**Core Document 7**

**RE: Planning application number 2014/2037/P (22 Lancaster Grove, London NW3 4PB)**

**RE: Planning application number 2014/2037/P (22 Lancaster Grove, London NW3 4PB)**

Impact on surface 5 (p.48-49):

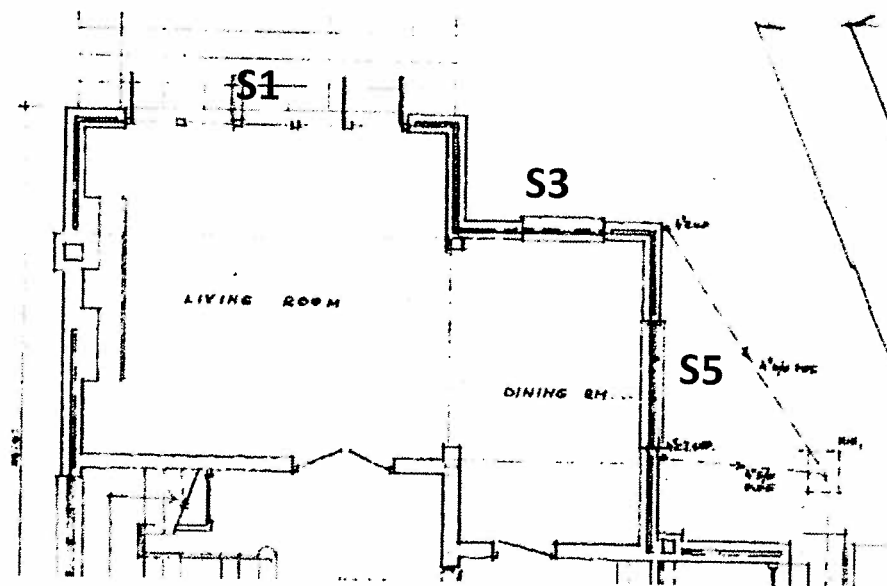
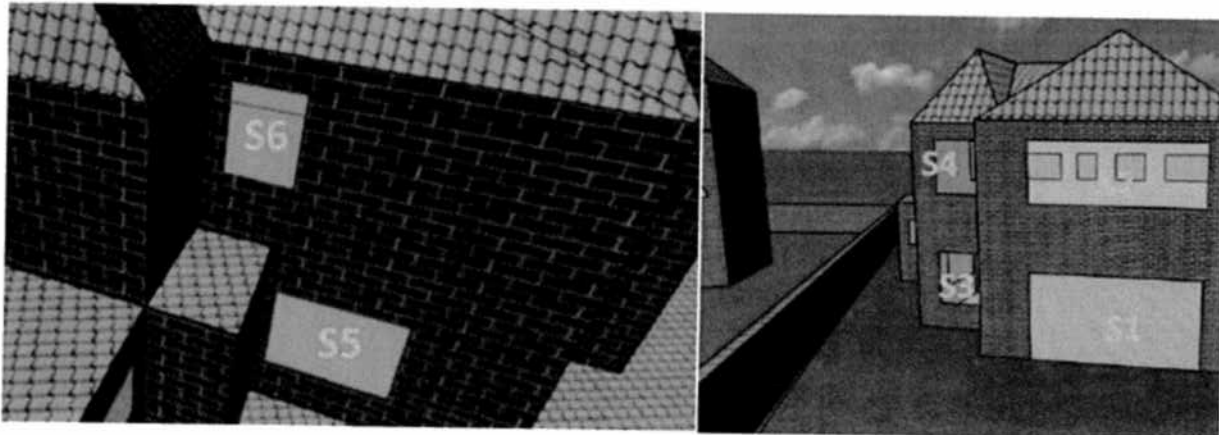
Both APSH values are below the 25% criteria, however, as it can be seen below, the **window S5 is not the only window of the dining room**. The dining room includes the windows S3 and S5, the main window being the South facing window S3. Therefore the impact on S5 can be considered **negligible** because the main window of the room S3 will not be adversely impacted by the proposed scheme and achieve adequate levels of sunlight (total APSH=27.26% > 25%) as stated in a.

*"a site visit was carried out on 06.03.14 and confirm that this surface is a secondary window into the rear living room. Therefore as the main window S3 is not impacted by the proposed scheme it can be concluded that the impact on S5 is negligible"*

Surface 3 – 24 Lancaster Grove - GF

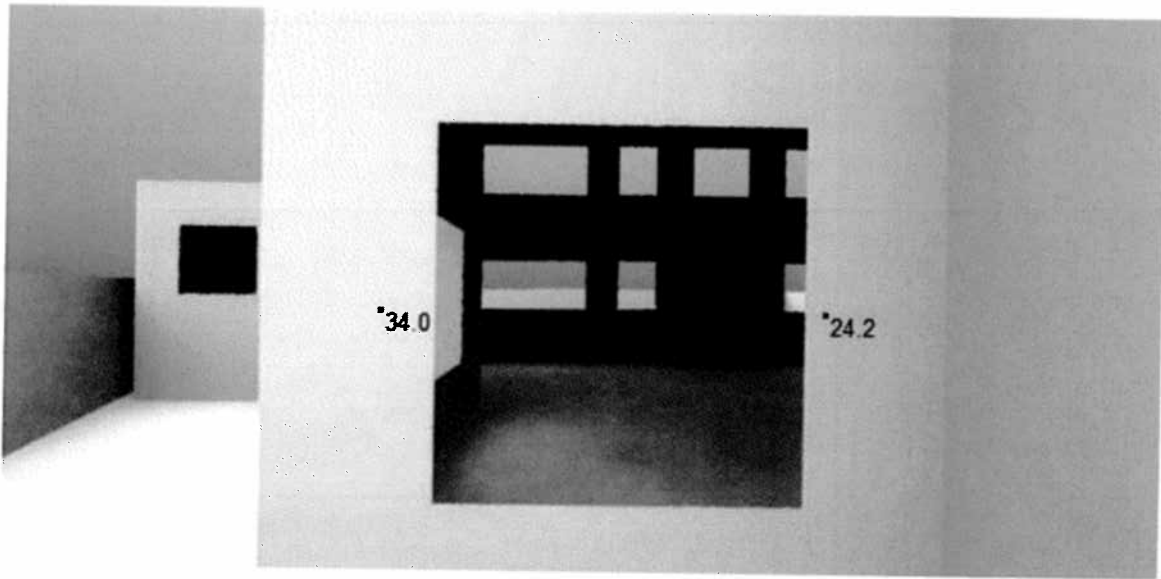
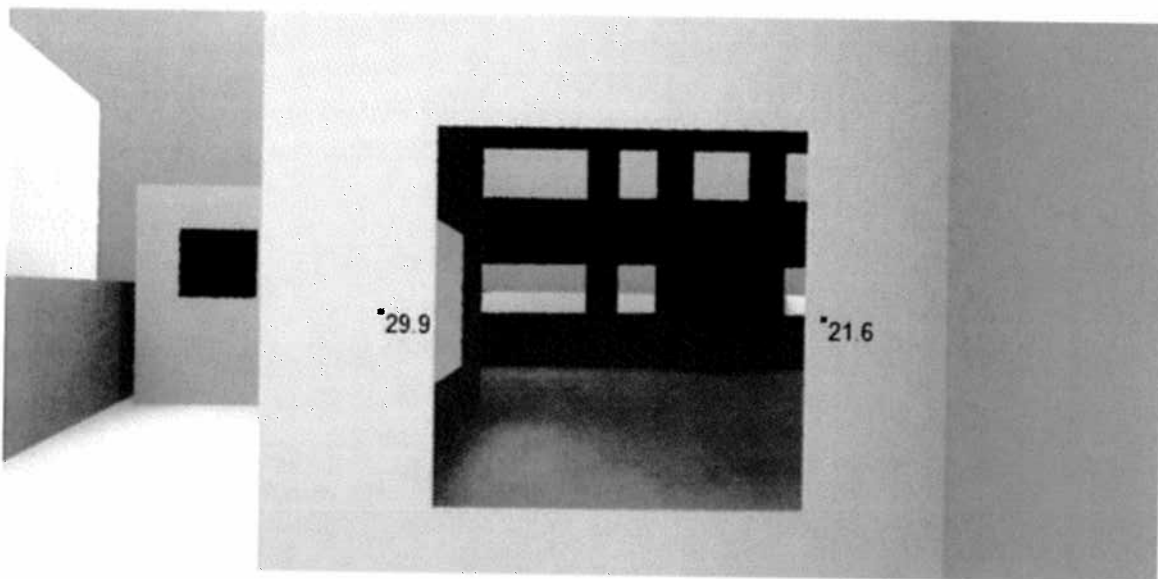
Existing Sample of VSC			
S3	34.0	24.2	Average 29.10

Proposed Sample of VSC			
S3	29.9	21.6	Average 25.75

Ratio of 88.5% -> impact negligible

Surface 5 – 24 Lancaster Grove - GF

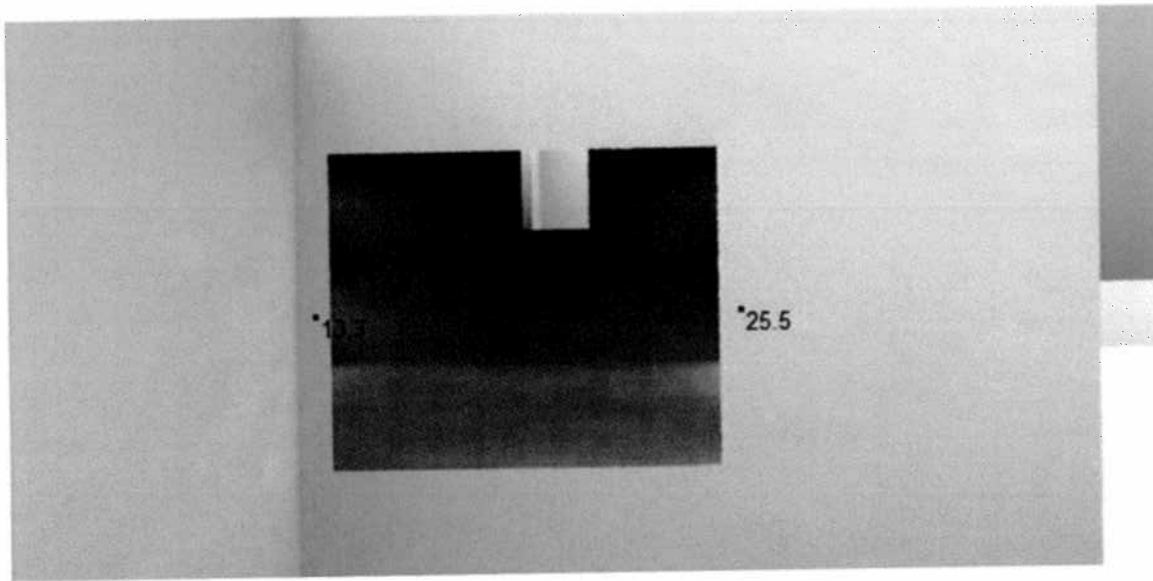
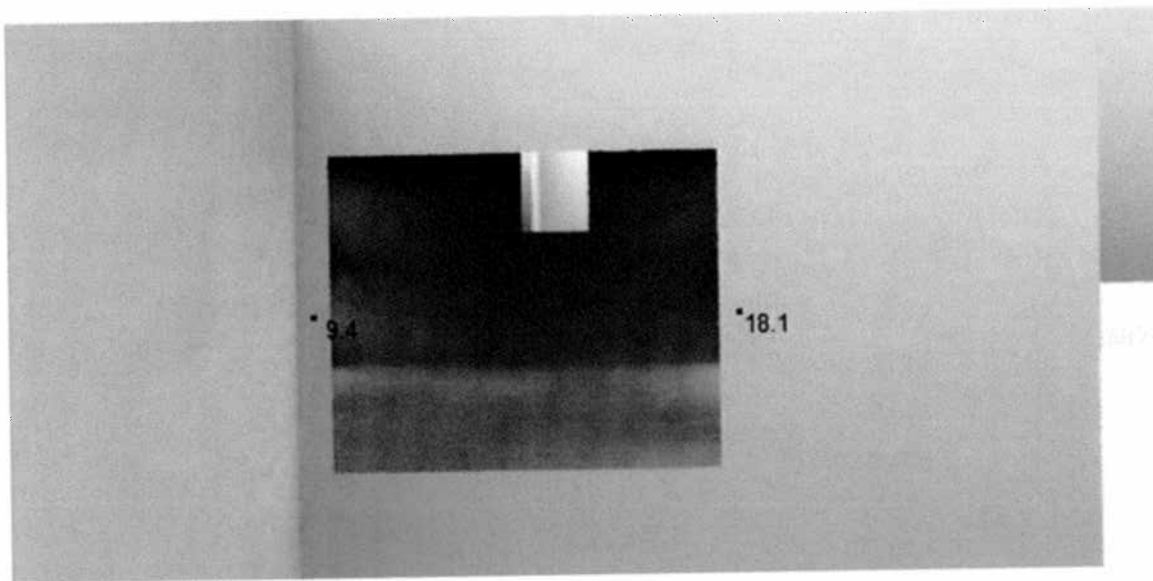
Existing Sample of VSC			Average
S5	13.3	25.5	19.40

Proposed Sample of VSC			Average
S5	9.4	18.1	13.75

Ratio of 71% -> minor adverse impact

However, S5 is considered as a secondary window to the dining room.

24 Lancaster Grove

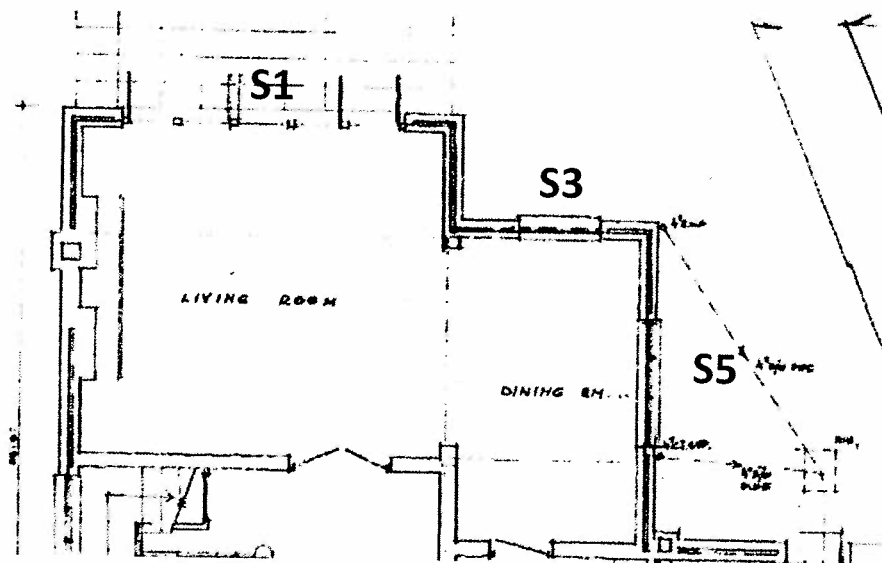
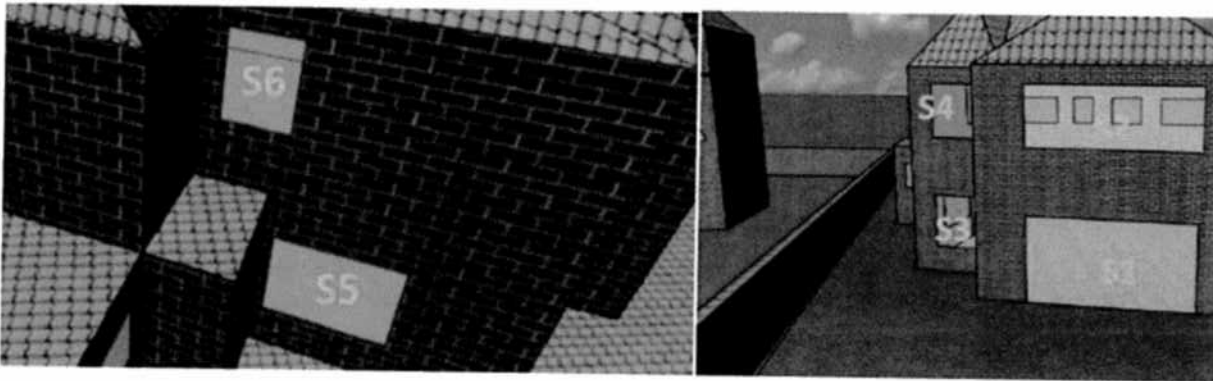
Furthermore, the above floor plan shows that the living and dining room are open plan. Therefore even if S5 loses some daylight levels, the room will still receive daylight from its main South facing window S3 and also from the large South facing sliding window S1.

*"a site visit was carried out on 06.03.14 and confirm that this surface is a secondary window into the rear living room. Therefore as the main window which is facing South S3 is not impacted by the proposed scheme it can be concluded that the impact on S5 is negligible"*

Surface 14 – 24 Lancaster Grove - GF

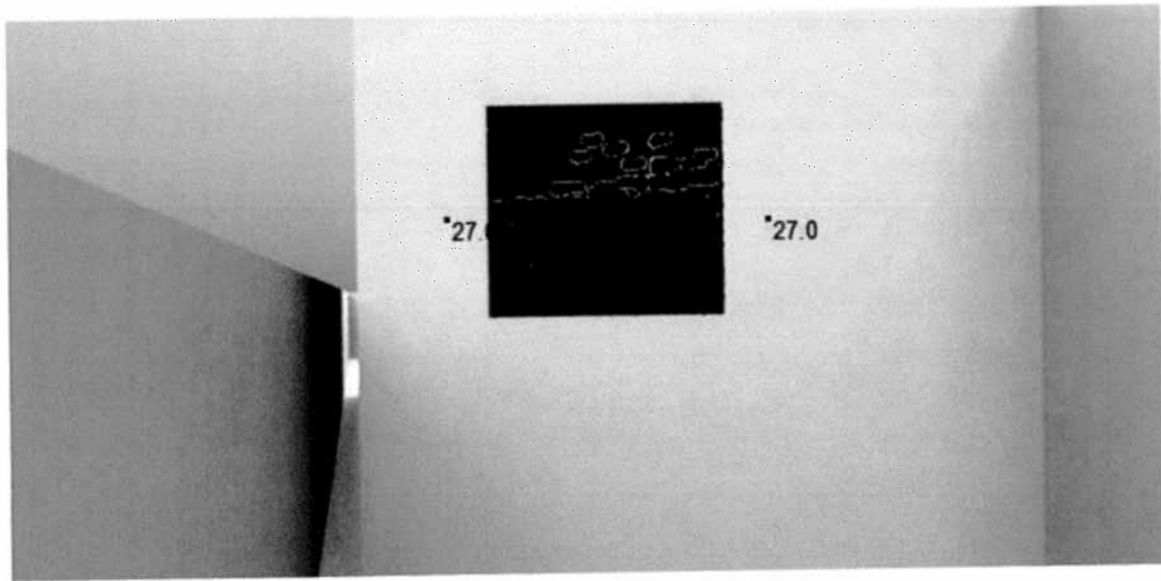
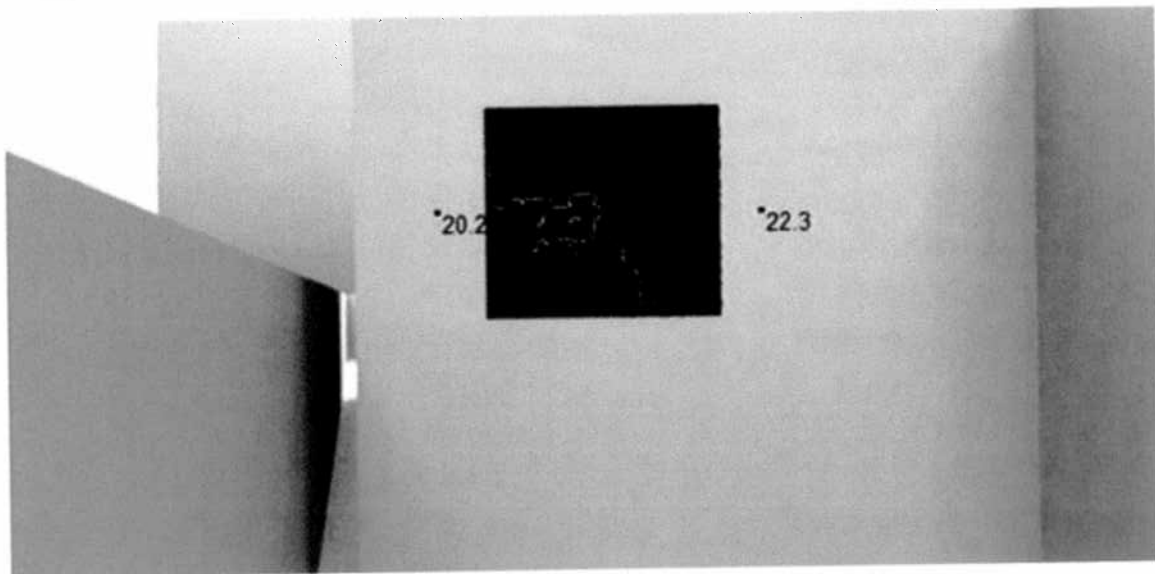
Existing		Sample of VSC		Average
S14	27.0	27.0	27.0	27.00

Proposed		Sample of VSC		Average
S14	20.2	22.3	22.3	21.25

Ratio of 80% -> negligible

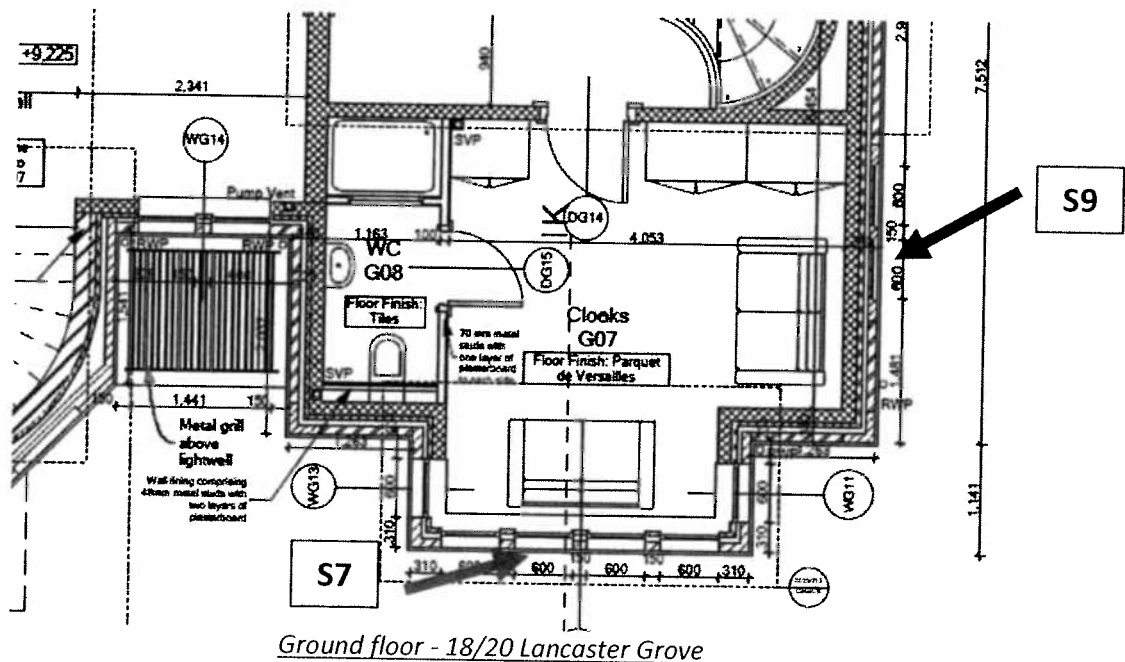
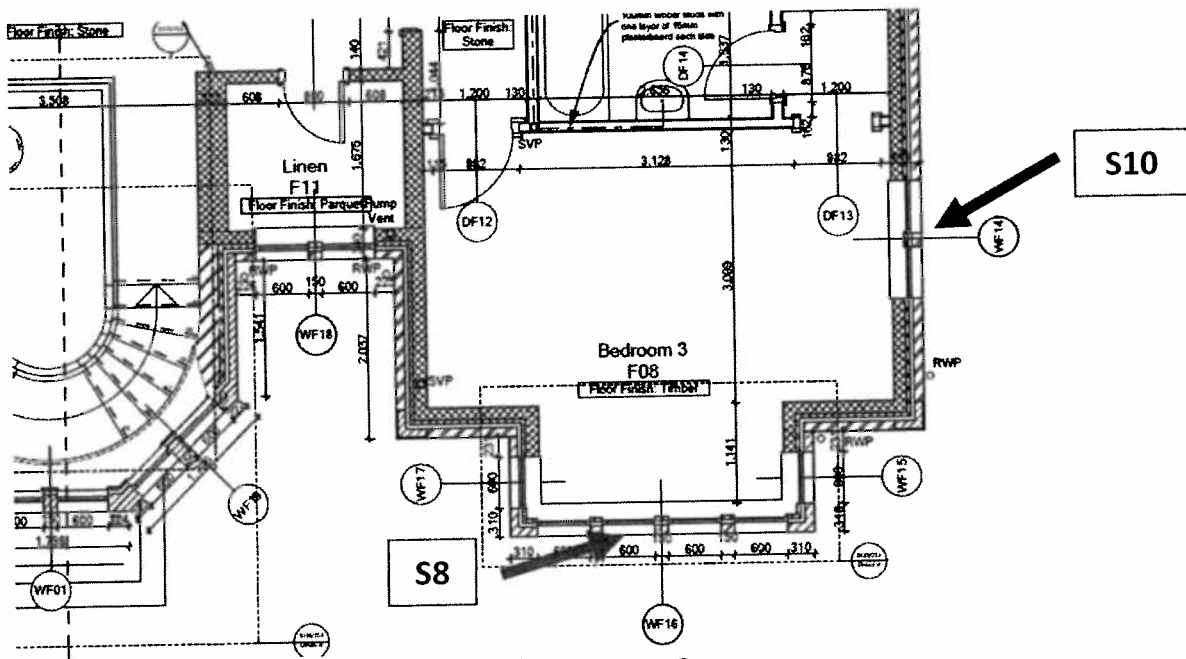
In reference to surfaces 9 and 10, it is explained in the report why the results can be considered "negligible". That is why there is no mention of "moderate adverse" even if the ratio is below 0.7.

- The above drawings show that S9 and S10 are secondary windows and as the main windows S7 and S8 are not impacted by the proposed development it can be concluded that the impact on S9 and S10 is negligible. Furthermore the cloak room is not considered as a habitable room and the impact is therefore irrelevant on S9.
